Subject: **Appliance Efficiency Standards for Battery Chargers (Docket # 09-AAER-2)**

At the recent October 11, 2010 workshop on this topic, the CEC invited stakeholders to comment on the recently-published "Analysis of Standards Options for Battery Charger Systems," which was commissioned by Pacific Gas and Electric (PG&E) and authored by Ecos Consulting. This document contains data on the performance of Battery Charging Systems in the state of California, and recommendations as to how to improve the energy efficiency of these systems.

Figure 2 Multi-port charger design meeting CEC proposal

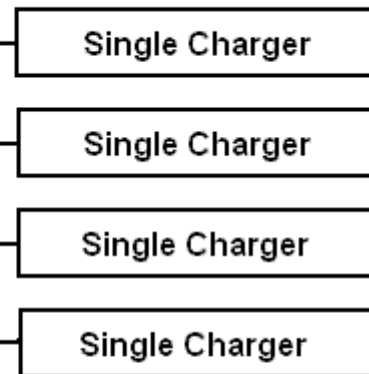
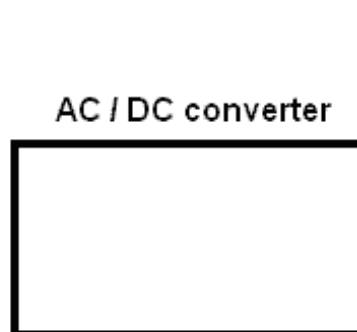
In the BCS CASE proposal, the difference in Maintenance and No Battery power is $.5 - .3 = .2W$. In the design of a multi-port charger, such restrictive limits will drive manufacturers to replace multi-port chargers with multiple single chargers, resulting in a net increase of power drawn from the grid. This solution will also increase the cost of the unit to the consumer. For example, a four-unit charger, which could use 0.65 W in maintenance mode, would be re-designed as 4 single unit chargers consuming 0.8 W to do the same work. See below for an illustration of this example.

Multiple Power Supplies

$4 \times .3 = 1.2W$
No Battery
Power

Multiple Chargers

$4 \times (.5 - .3) = .8W$
Maintenance - No Battery
Power

*.9W more drawn from the grid in No Battery mode.
.6W more drawn from the grid in Maintenance mode.
Even more connectors and housings. No shared resources.*

The approach proposed in Figure 3 is superior in energy efficiency and cost to the design in Figure 2. We strongly encourage the CEC to include allowances in power for multi-port chargers.

Figure 3 Multi-port charger design meeting new proposal

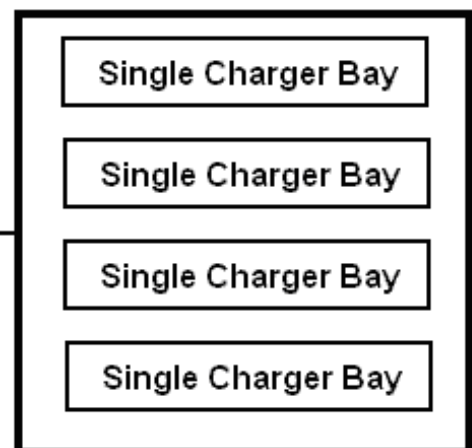
Single Power Supply

$.3W$
No Battery
Power

Multi-port Charger

$.2 + 3 \times .15 = .65W$
Maintenance - No Battery
Power

*No additional power drawn from grid in No Battery mode.
Only .45W additional drawn from the grid in Maintenance mode.
Fully shared resources - lowest cost.*
